**STAFF RECOMMENDATION**  
**1502 Shelby Avenue**  
**May 15, 2019**

**Application:** New Construction—Infill  
**District:** Lockeland Springs-East End Neighborhood Conservation Zoning Overlay  
**Council District:** 06  
**Base Zoning:** R6  
**Map and Parcel Number:** 08313050200  
**Applicant:** Cheyenne Smith  
**Project Lead:** Melissa Sajid, [melissa.sajid@nashville.gov](mailto:melissa.sajid@nashville.gov)

**Description of Project:** Application is to construct a single-family infill.

SITE PLAN AND FOUNDATION PLAN

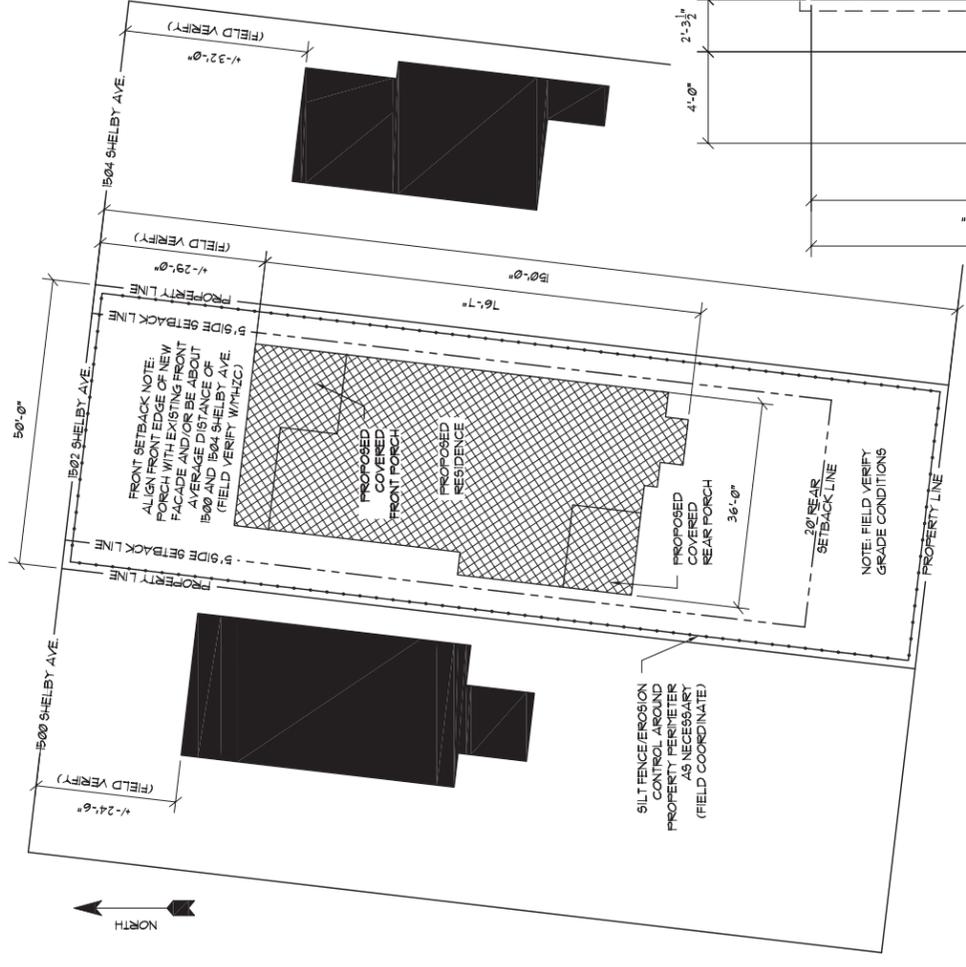
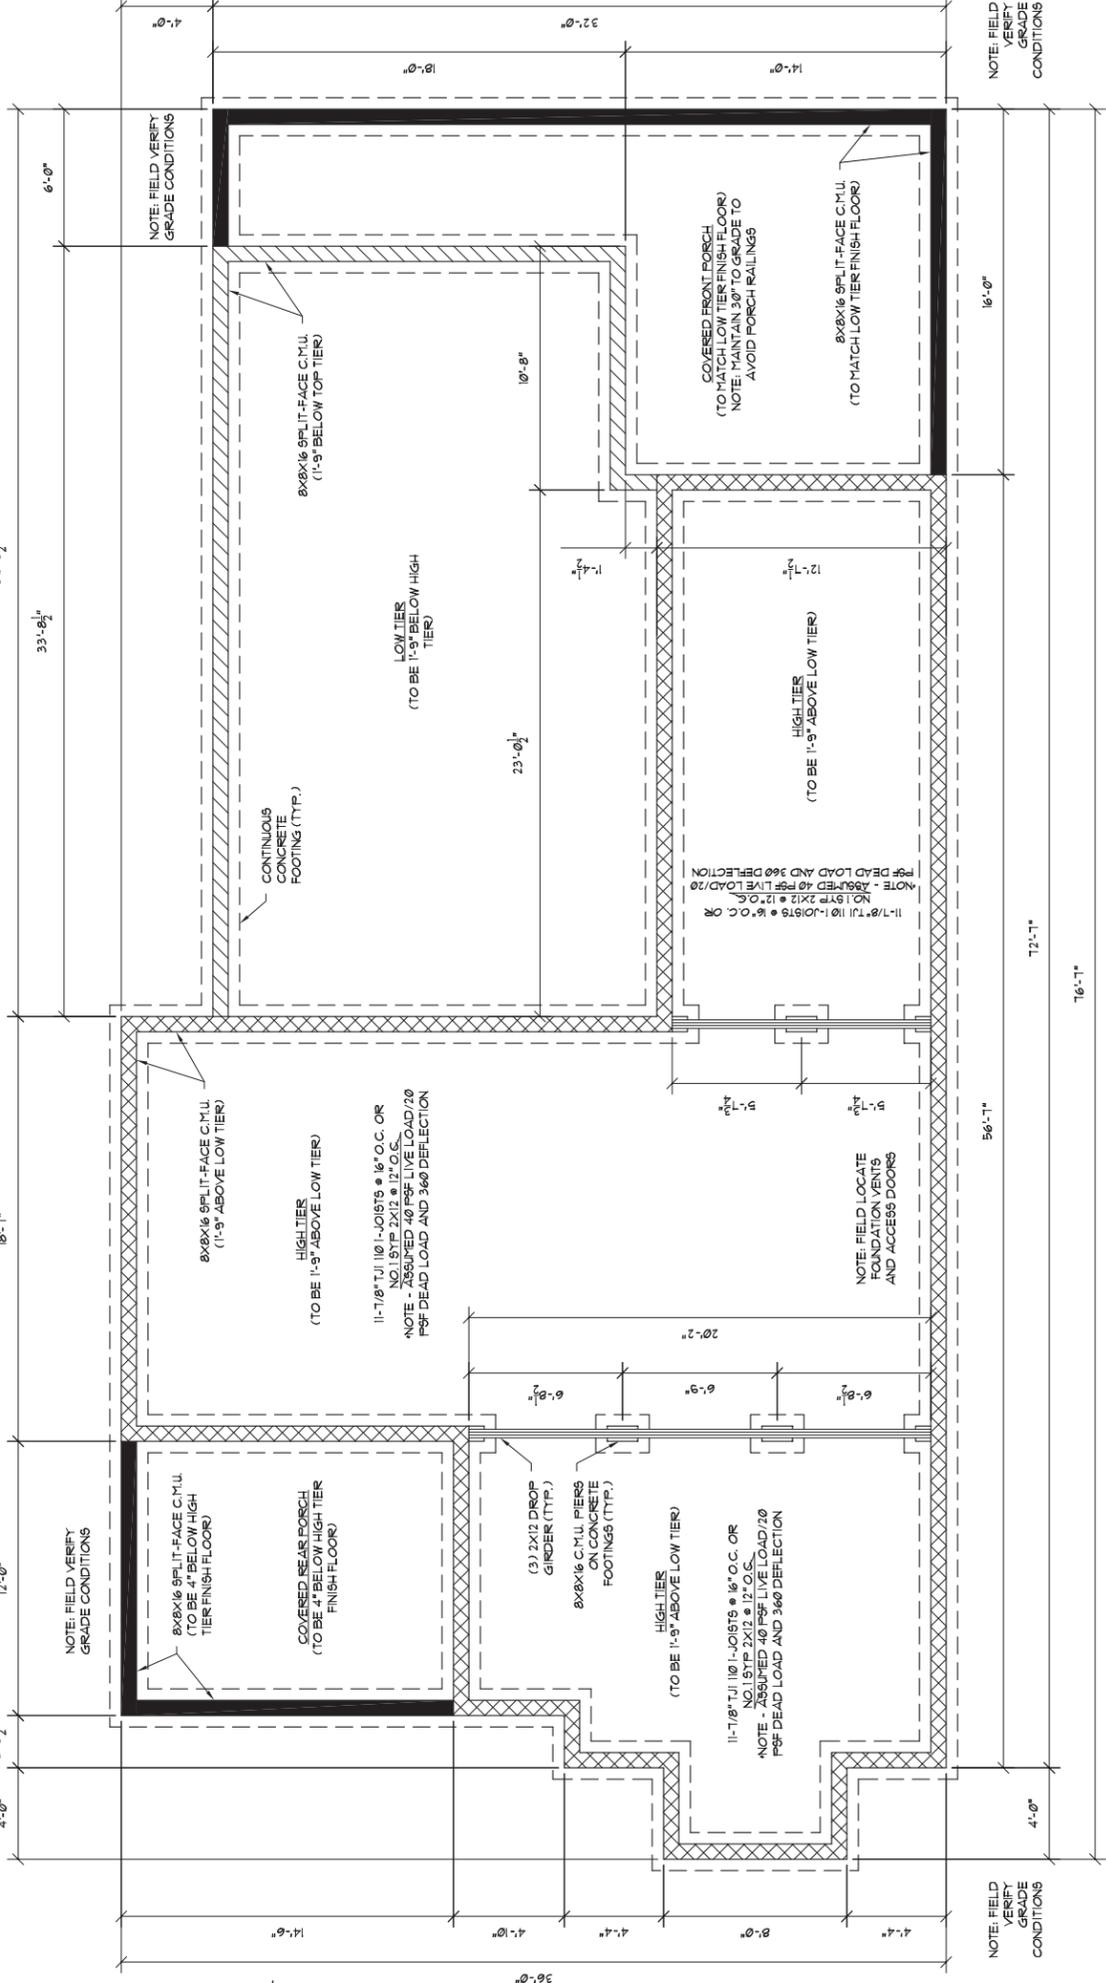
Setback & Rhythm of Spacing: The proposed infill will meet all base zoning setbacks. It is seven feet (7') from both side property lines and more than forty-two feet (42') from the rear property line. The front setback will be approximately twenty-nine feet (29'), which is approximately halfway between the houses on either side. Staff finds that the proposed setbacks meet Section II.B.3. of the design guidelines.

Appurtenances & Utilities: The existing walkway from the sidewalk and driveway off the alley will be retained. The location of the HVAC and other utilities was not noted. Staff recommends that the HVAC be located on the rear façade, or on a side façade beyond the midpoint of the house. With staff's approval of the HVAC location, staff finds that the project's appurtenances meet Section II.B.9. of the design guidelines.

1. The finished floor height shall be consistent with the finished floor heights of the adjacent historic houses, to be verified by MHZC staff in the field;
2. The front setback shall be consistent with the buildings to either side, to be verified by MHZC staff in the field;
3. Staff approve the final selections of the trim, roof color, porch posts, rear porch railing, windows, and doors prior to purchase and installation; and
4. The HVAC be located behind the house or on either side, beyond the mid-point of the house.

EXTERIOR ELEVATIONS

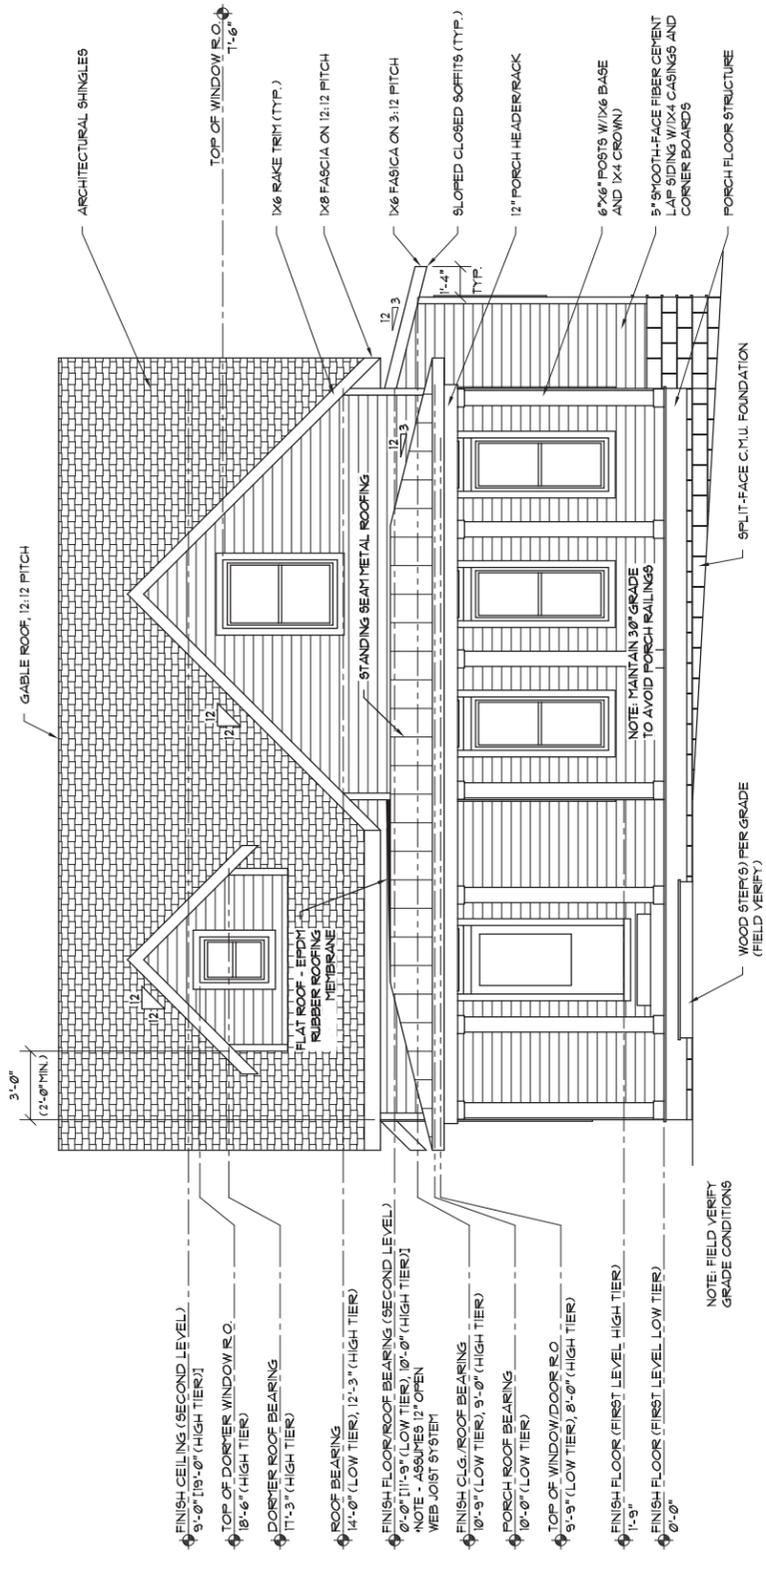
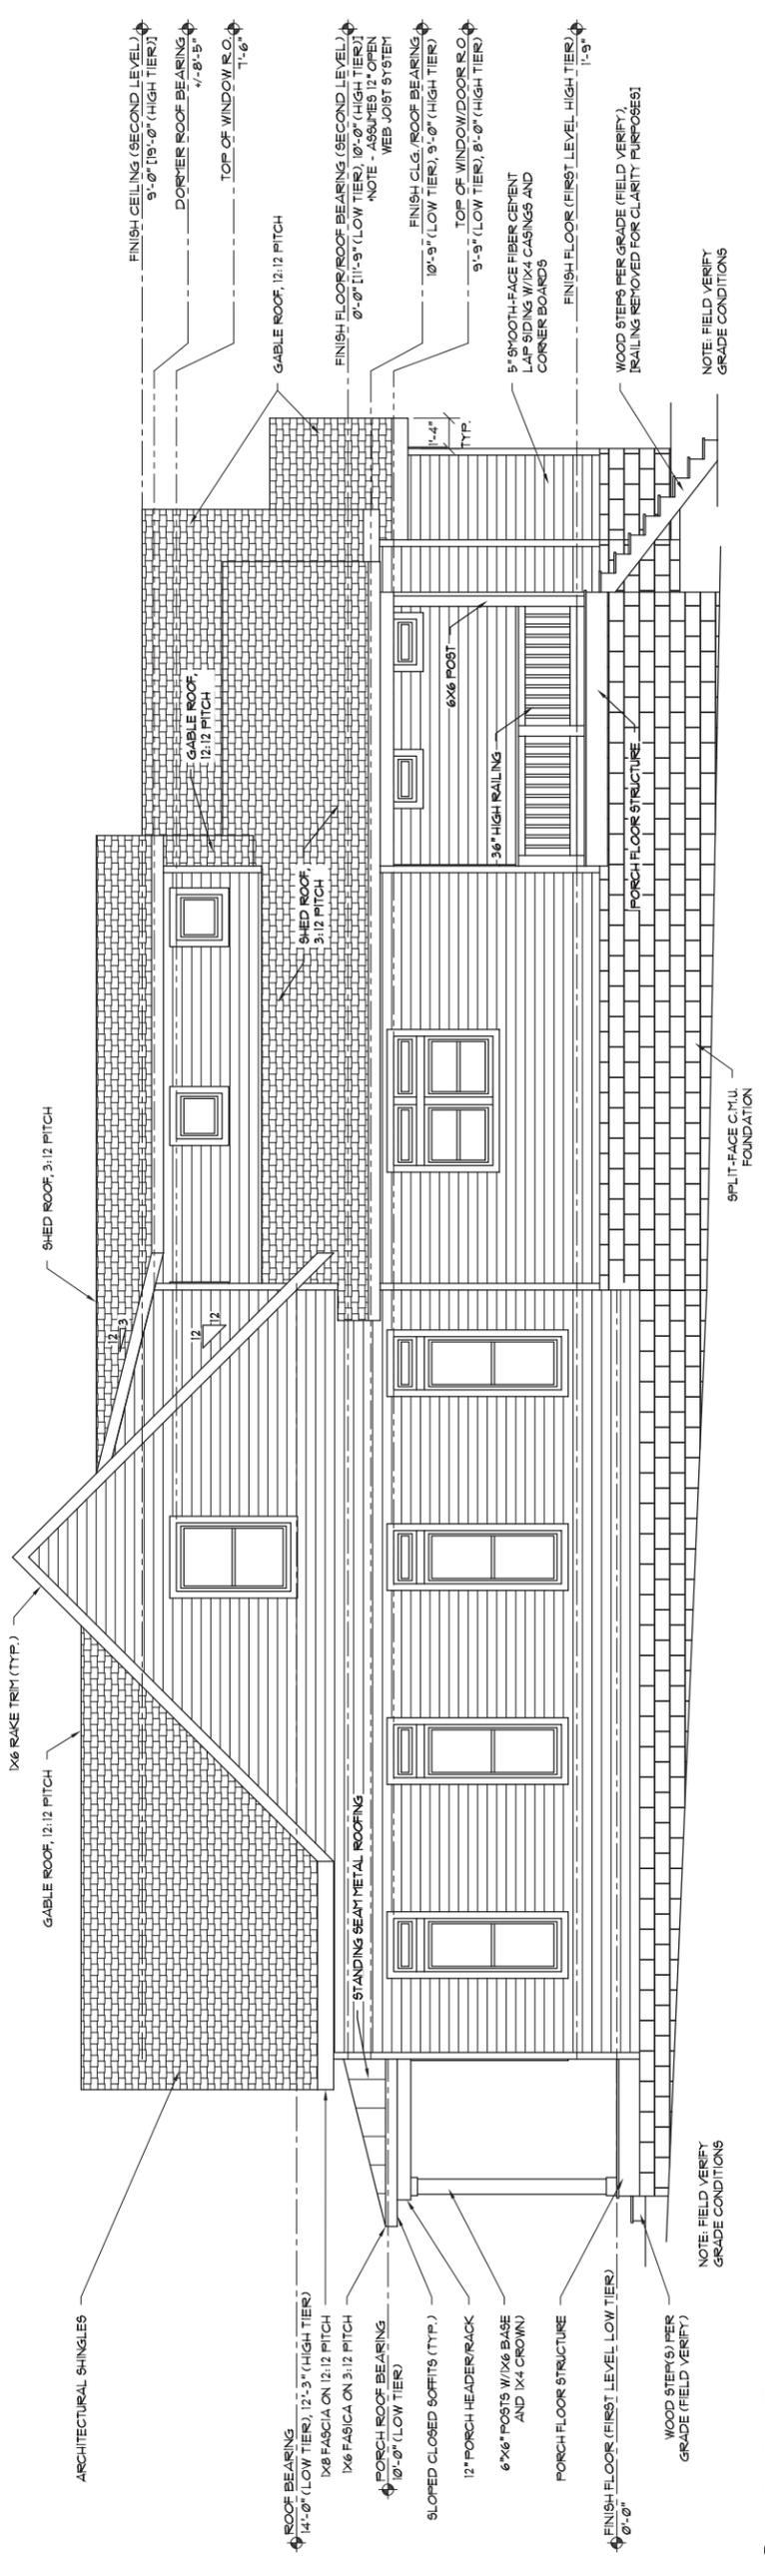
**Height & Scale:** The proposed infill will be one and one-half stories with an eave height of thirteen feet, six inches (13'-6") and a ridge height of approximately twenty-nine feet (29') from average grade at the front. Staff finds that the one and one-half story form and overall height is appropriate since the historic context includes one, one and one-half and two-story home with ridge heights of up to thirty feet (30').

Roof form: The primary roof form is a cross-gable with a 12/12 pitch. The porches, side dormers, and single-story wider portion on the right side incorporate shed roofs with a 3/12 pitch. Staff finds that the infill's roof forms to meet Section II.B.5. of the design guidelines.

Proportion and Rhythm of Openings: The windows on the proposed infill are all generally twice as tall as they are wide, thereby meeting the historic proportions of openings. There are some smaller square windows located on the right side façade and on the rear. Staff finds these windows to be appropriate as they are located beyond the midpoint of the house and are not likely to be visible from the street. There are no large expanses of wall space without a window or door opening. Staff finds the project's proportion and rhythm of openings to meet Section II.B.7. of the design guidelines.
